UNITED STATES PATENT AND TRADEMARK OFFICE

APPLICATION NO.	FILING DATE	FIRST NAMED INVENTOR	ATTORNEY DOCKET NO.	CONFIRMATION NO.
10/811,235	03/26/2004	Mario Spatafora	U 015109-7	9021
140	7590	07/12/2006	EXAMINER	
LADAS & PARRY 26 WEST 61ST STREET NEW YORK, NY 10023			KIM, SANG K	
			ART UNIT	PAPER NUMBER
			3654

Office Action Summary

10/811,235

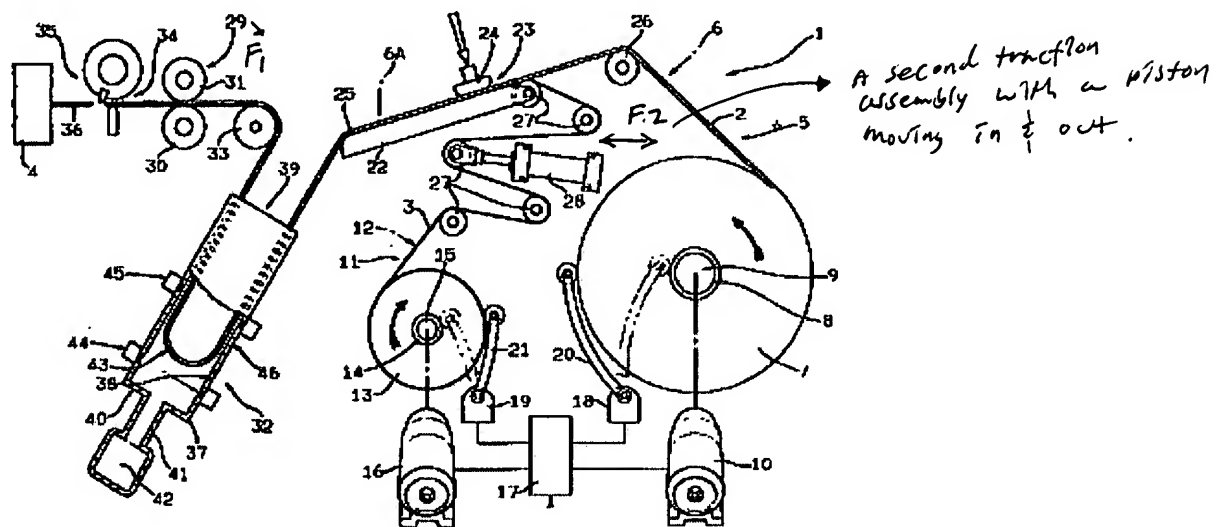
With respect to claim 1, EP '149 shows a device for feeding a continuous strip 2, a tear ribbon 3, a user machine 4, two reels 1, 13 with shafts 9, 15, first and second guides 26, 27 with respective paths 6, 12, a joining station 23 to form a composite strip 25, a traction assembly 29 to transmit a first pulling force (see illustration below, F1) and a second pulling force (see illustration below, F2) using a second traction assembly 27, 28 arranged between the reel 13 for the tear ribbon and the jointing station 23, on a

portion of the tear ribbon extending between its respective said reel 13 and the joining station 23, see illustration below.

Applicant's arguments filed on 6/9/06 have been fully considered but they are not persuasive with respect to claims 1-10. The drawing illustrated above is to show the applicant which element is considered to be a second traction assembly.

Examiner agrees with the applicant that the EP '149 device uses the actuator 28 with respective diverting roller 27 to vary the length of path with substantially no tension being applied to tear strip. However, the examiner disagrees with the applicant's assessment that the EP '149 device using the actuator 28 with respective diverting roller 27 cannot be considered as a second traction assembly.

The reference EP '149 uses the actuator 28 to vary the length of path to the tear strip by actuating the piston in and out. A second force is generated by moving the piston in and out, causing the web to vary the length as it goes into the joining station, thus, the actuator 28 with the roller 27 can be considered as a second traction assembly which can exert a force onto the web.
